APPEAL SUMMARY

Appeal ID: 20805

Project Address: 929 SW Salmon St

Building/Business Name: Fountain Place Apartments

NOTE: SEE DOOR SCHEDULE FOR FIRE RATED DOORS

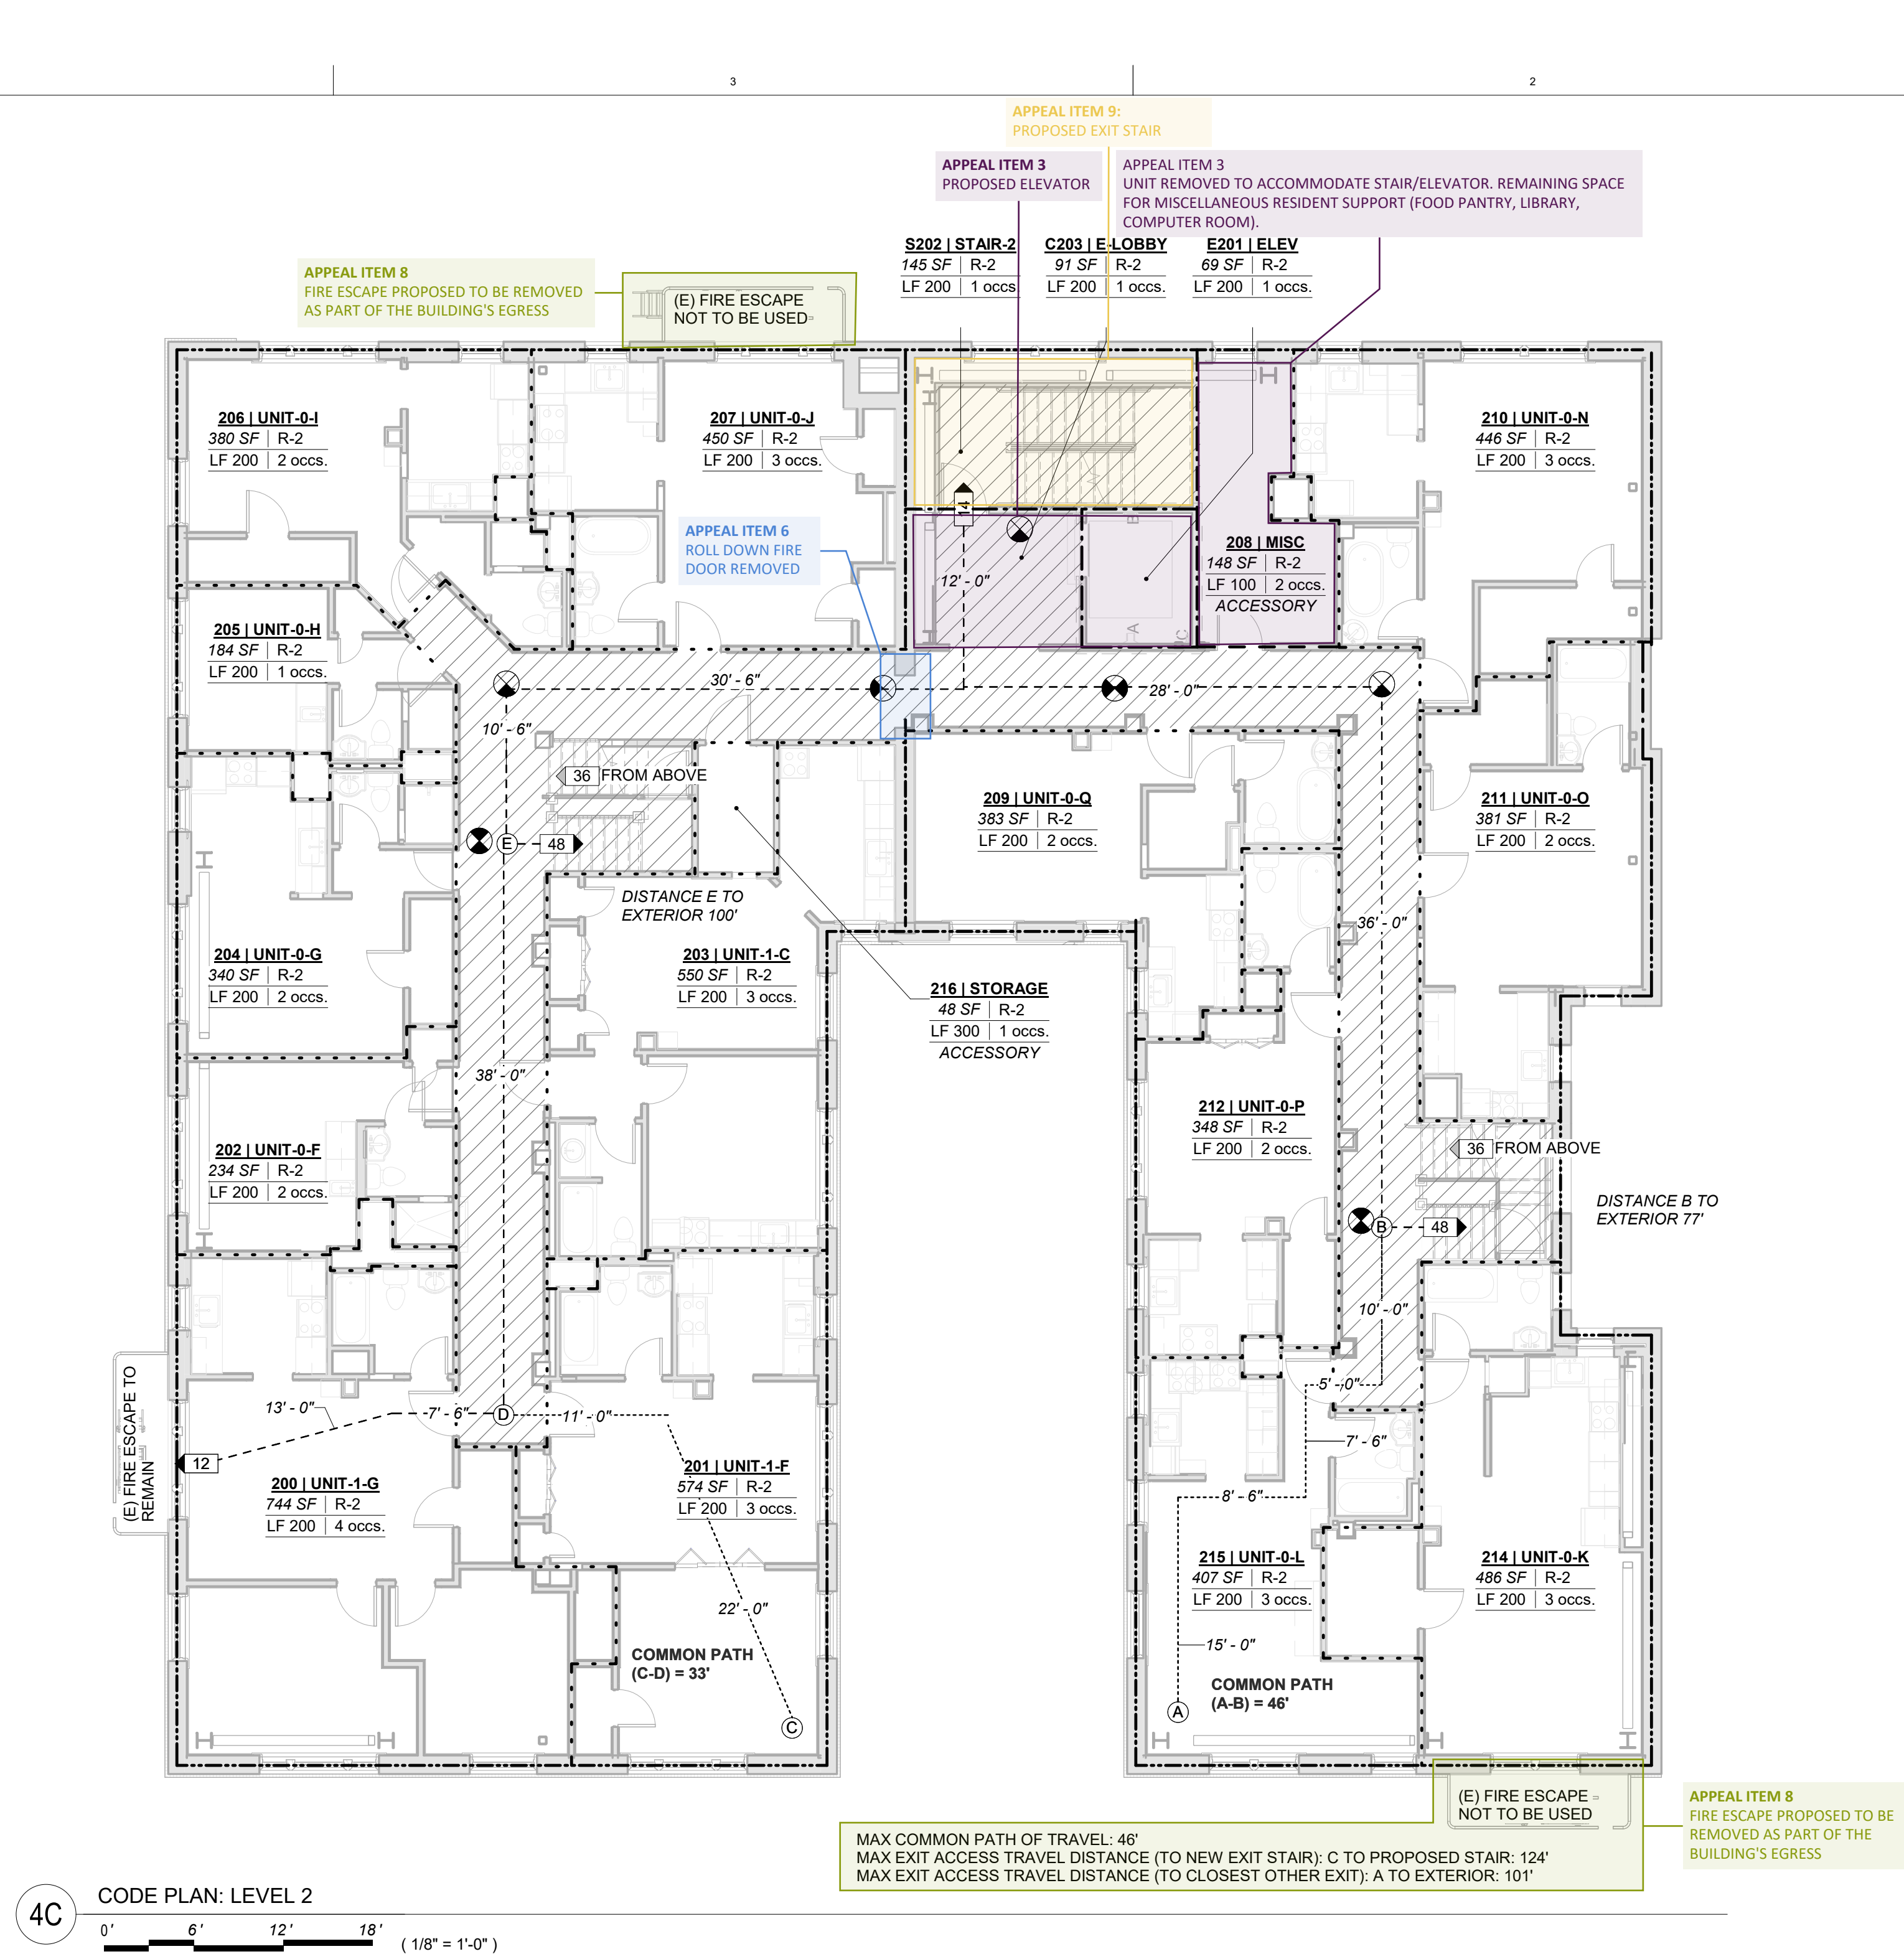
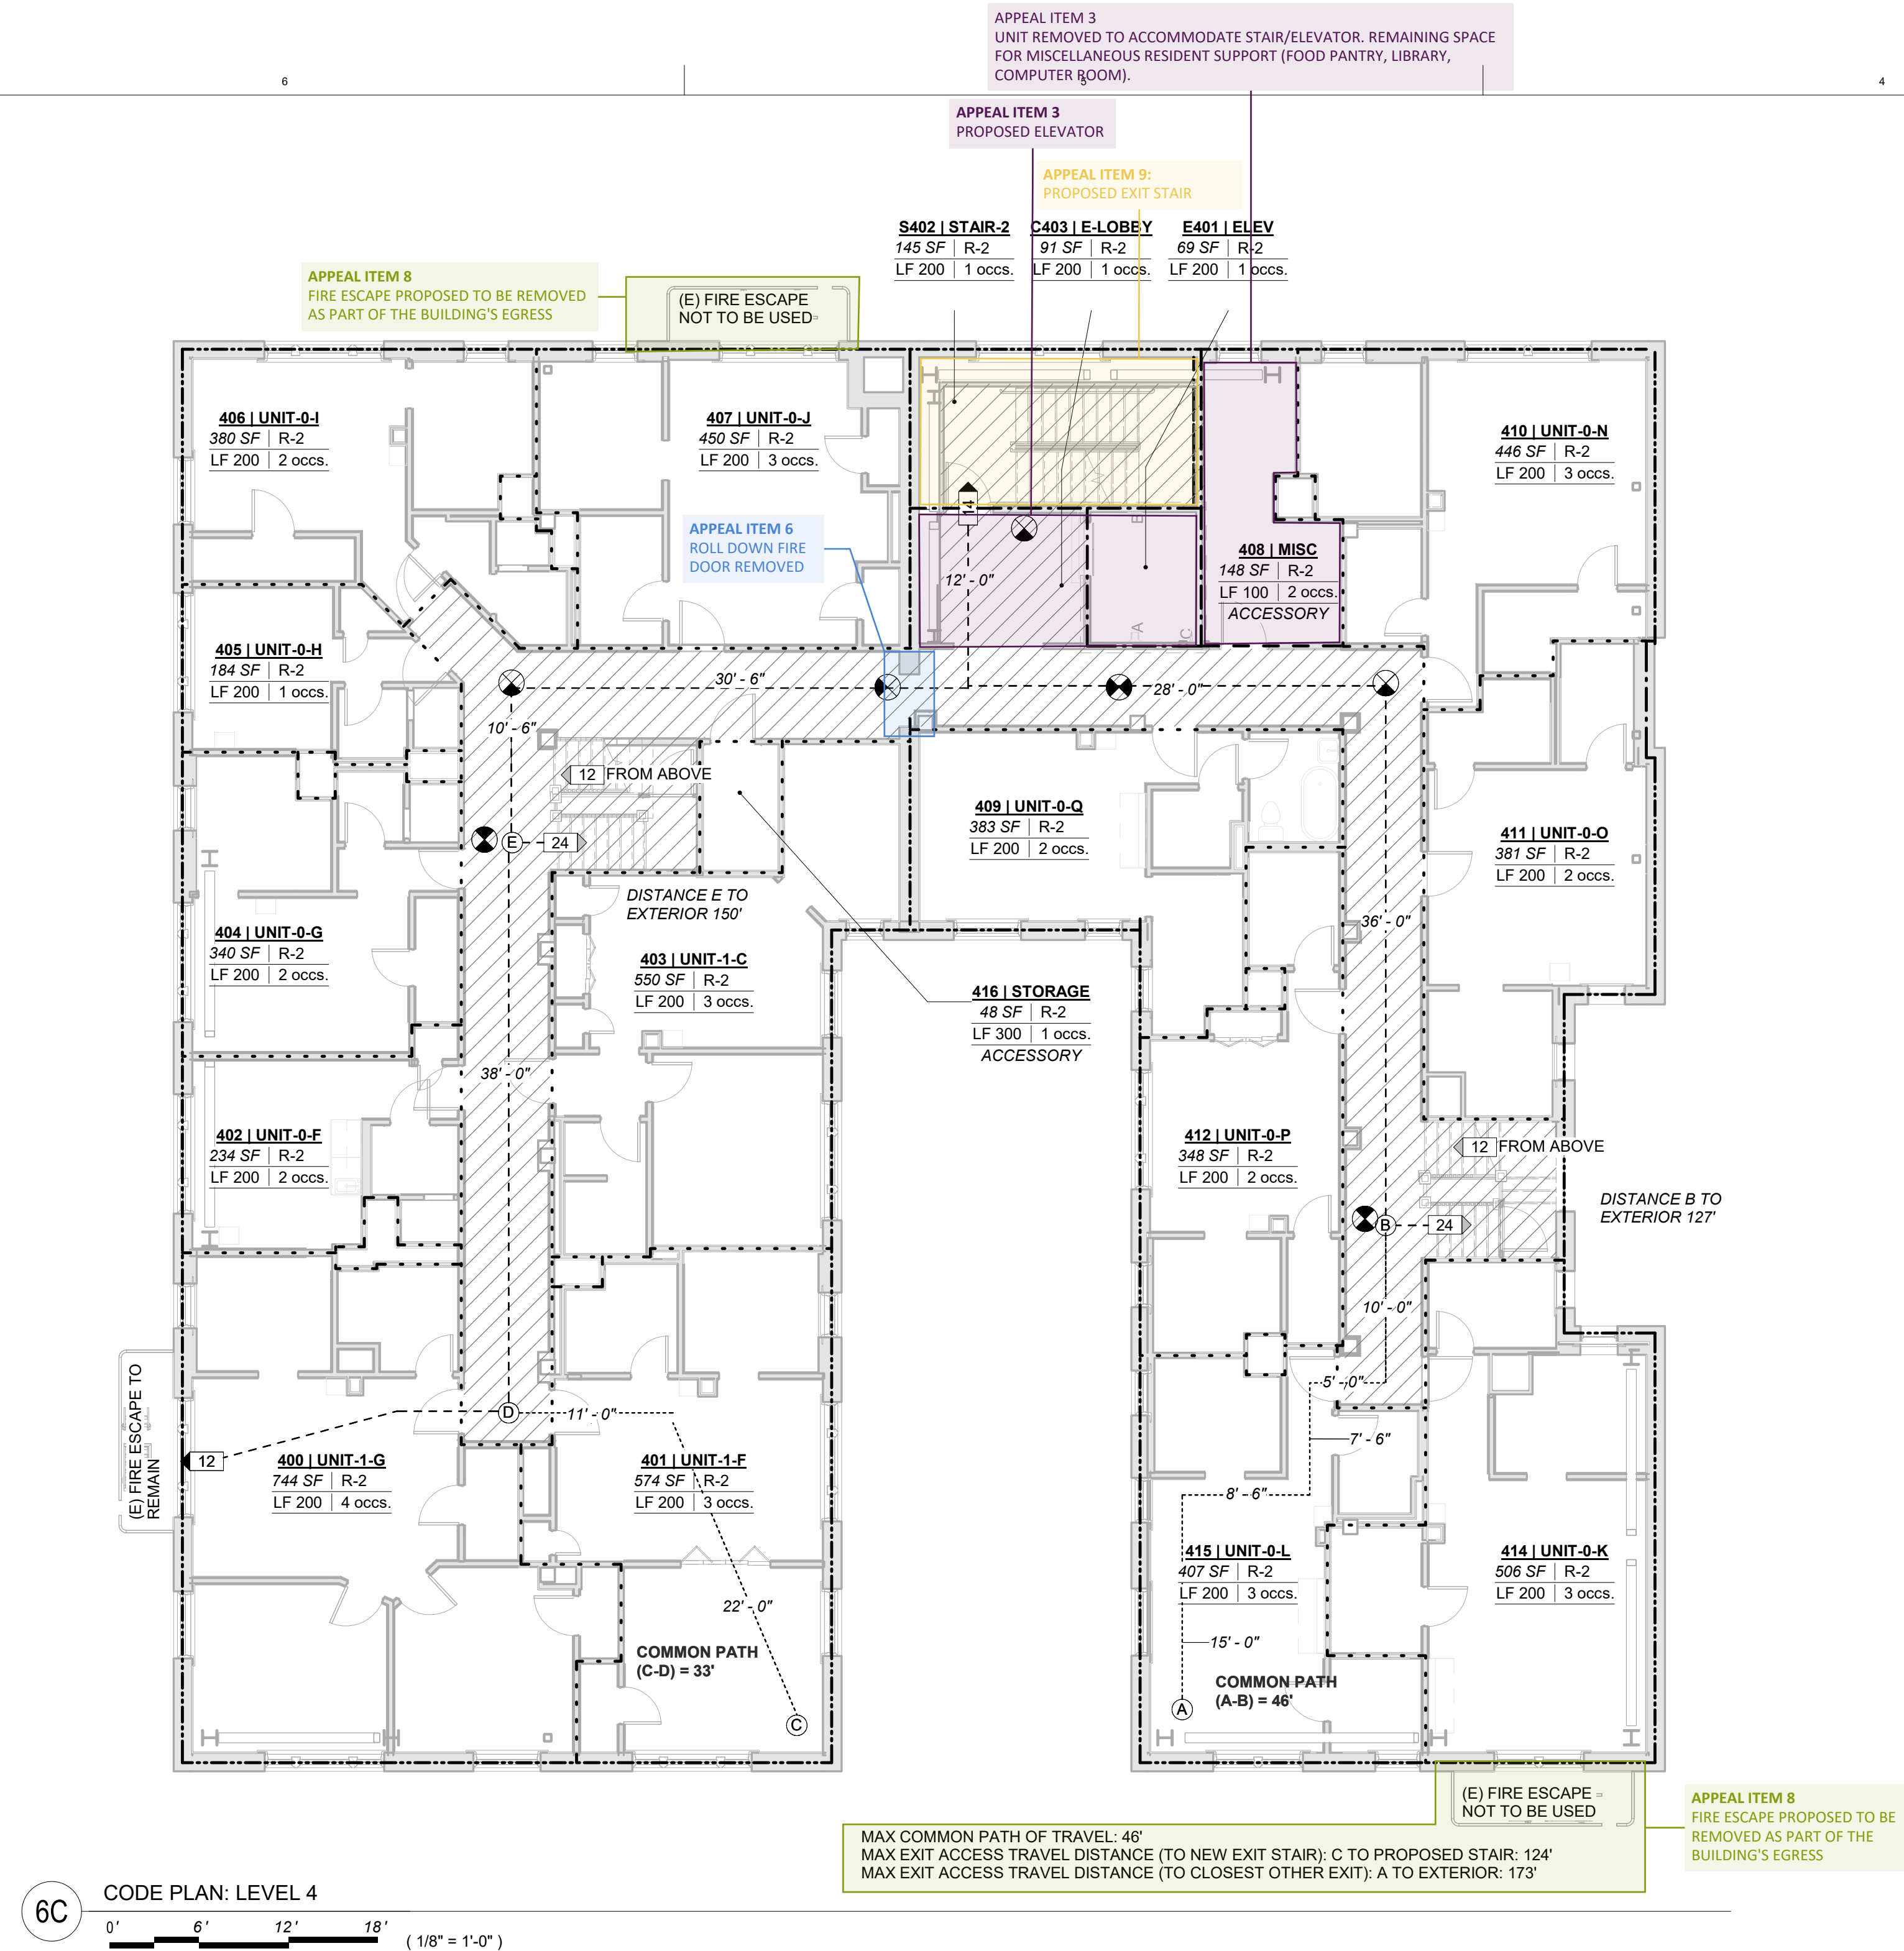
The existing building is separated into two wings by a 4-hour masonry wall. There is a single opening between the wings at each floor level. In the existing building roll-down fire doors protect the openings on Levels 2 – 5 and a self-closing door protects the opening at Level 1. There is no protection of the opening at Level 0.

In the event of a fire, the existing roll-down fire doors will prevent the west wing of the building from accessing the proposed egress stair. The proposed design is to no longer treat the masonry wall as a Fire Wall (per 706) and remove the roll-down fire doors. The proposed design will allow access to the egress stair from both wings of the building, significantly improving exiting. Reference sheets G-110/G-111 for existing conditions, and sheets G-115/G-116 for proposed.

Reason for alternative The removal of the roll-down doors will enable residents on the west wing of the building to access the new enclosed exit stairway and will improve egress for all occupants. The building meets the building area requirements per Section 503 without the Fire Wall. Section 503 notes a maximum building story area of 16,000 sf – the existing building story area including both wings is 7,600 sf, less than half the maximum prescribed per code. The total building area also falls under the threshold prescribed by Section 503 for a Type IIIB building with R-2 occupancy. Code notes a maximum area of 64,000 sqft (4 stories at 16,000 sqft per story). The total area of the existing building falls well under this threshold at 45,336 sqft. With the proposed configuration the Fire Wall is not required per code. The masonry wall is proposed to remain; however, the openings will no

4. **Increase in bottom of door clearance to finish floor: Granted as proposed.**
5. **Replacement of fire escape access doors: Granted as proposed.**
6. **Removal of roll down fire doors between East and West wings: Denied. Proposal does not provide equivalent Life Safety protection.**

5A INTERIOR DETAIL: TYP - CORRIDOR DOOR THRESHOLD
0" 3" 6" 9" (3" = 1'-0")

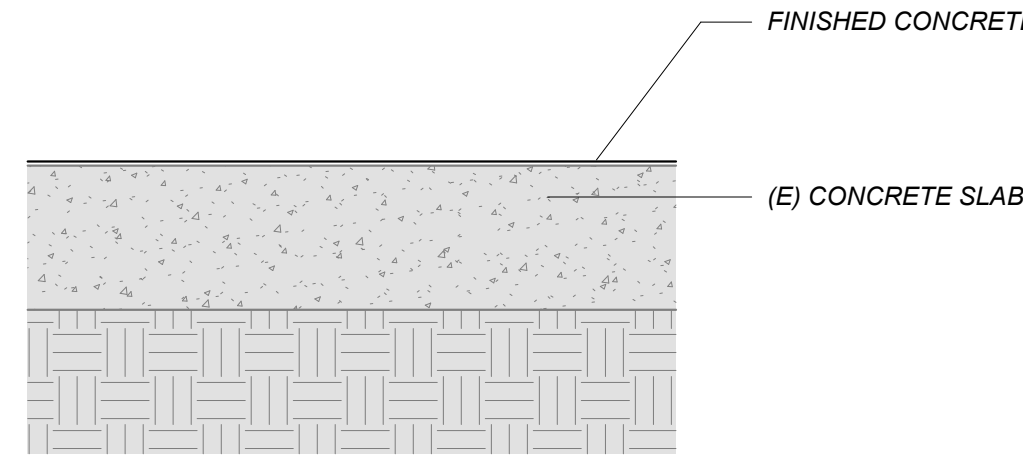
Code Section	Chapter 13 Systematic Inspection Program: Section 1313 of Chapter 13 of the Appendix of the 1973 Edition of the Uniform Building Code
Requires	As a Chapter 13 Building, any modifications to existing means of egress systems will require a building code appeal for approval.
Proposed Design	<p>Fountain Place Apartments is a 5 story (plus a basement), unreinforced masonry apartment building in Portland, Oregon serving low-income residents. The proposed scope of work is to seismically upgrade the building (and ancillary work) and improve building egress, reducing existing 80 units to 74 units.</p> <p>Scope of work in the building is limited to structural upgrade of the building and replacing elements where installation of new structure requires demo of existing elements. Most finish floors will require replacement in order to accommodate a horizontal diaphragm, which will result in a new finish floor height approximately ¼" lower than the existing floor. All existing doors will remain in place during construction, therefore the clearance at the bottom sill of the door will increase ¼". The existing sill clearance ranges from ¼" to ½", therefore the total sill clearance with the replaced floor will be maximum ¾". Section 716.5 requires fire doors be rated installed according to NFPA 80. The increase in gap below the doors is will meet NFPA 80, Section 6.3.1.7.1 max clearance at the sill of doors of ¾". Reference sheet G-551 detail 5A for proposed detail at existing corridor doors to remain.</p>

Reason for alternative	<p>The alteration is a direct result of changes to the horizontal assembly as required by the seismic upgrade. Due to scope of work limited to the seismic upgrade and limited budget, the existing doors do not require replacement and will be left in place.</p> <p>No alterations will be made to existing corridor assembly and no additional door openings will be added. In addition, the corridors have an automatic sprinkler system per the 1974 building appeal.</p>
